[Docket No. FAA–2023–1814; Project Identifier AD–2023–00773–T; Amendment 39–22541; AD 2023–17–14]

#### Airworthiness Directives; The Boeing Company Airplanes

**SUMMARY:** The FAA is superseding Airworthiness Directive (AD) 2022–18–11, which applied to all The Boeing Company Model 777 airplanes. AD 2022–18–11 required repetitive inspections for cracking of the left- and right-side ring chords, repair angles, front spar lower chords, and front spar webs (depending on configuration) common to a certain underwing longeron; modification of the front spar lower chord for some airplanes; repetitive post-modification inspections; and applicable on-condition actions. This AD was prompted by a report of a crack found in a front spar lower chord, and the determination that errors in the service information mandated by AD 2022–18–11 introduced a new unsafe condition related to the application of

**Figure 1 to paragraph (h)(4)—Cap seal minimum thickness (all dimensions in inches)**

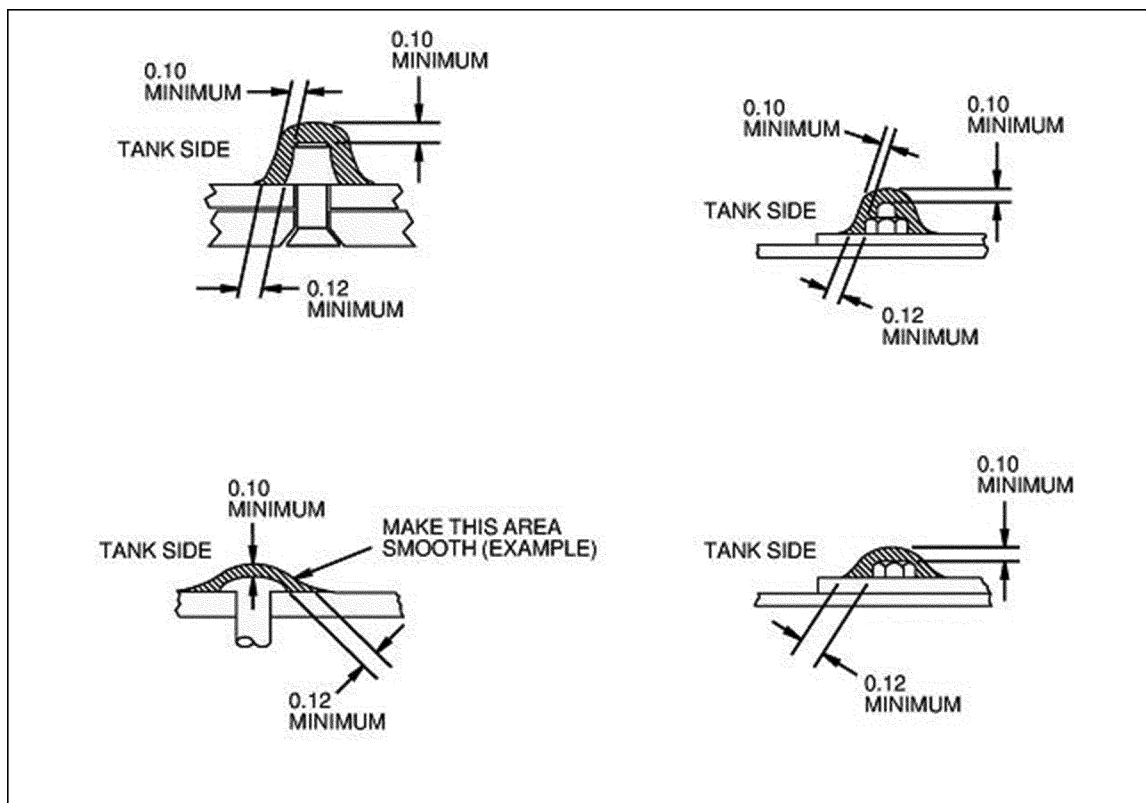
(4) During application of any cap seal to a fastener, fastener head, and fastener threads and collars, as required by this AD, the cap seal must be applied with a thickness equal to or greater than the dimensions specified in figure 1 to paragraph (h)(4) of this AD.

(6) Where Boeing Alert Requirements Bulletin 777-57A0122 RB, dated October 8, 2021, requires inspections that may require the removal of fastener cap seals, this AD requires that if the cap seal is removed, a cap seal of BMS 5-45 sealant be reapplied with a thickness equal to or greater than the dimensions specified in figure 1 to paragraph (h)(4) of this AD before further flight after completion of the inspection.

(ii) All cap seals were applied using procedures with thickness dimensions greater than or equal to those given in figure 1 to paragraph (h)(4) of this AD.

(2) If any cap seal was applied using procedures with thickness dimensions less than those given in figure 1 to paragraph (h)(4) of this AD, or if the maintenance records do not definitively specify the procedures used: At the applicable time specified in paragraph (i)(2)(i) or (ii) of this AD, replace the cap seal in accordance with the Accomplishment Instructions of Boeing Alert Requirements Bulletin 777-57A0122 RB, dated October 8, 2021, using a cap sealing procedure with thickness greater than or equal to the dimensions given in figure 1 to paragraph (h)(4) of this AD.

(3) For any cap seal that was not applied, or for any cap seal that was removed for inspections and not replaced, or if the maintenance records do not definitively specify the procedures used: At the applicable time specified in paragraph (i)(3)(i) or (ii) of this AD, apply a cap seal of BMS 5-45 sealant using an accepted method with thickness greater than or equal to the dimensions given in figure 1 to paragraph (h)(4) of this AD.
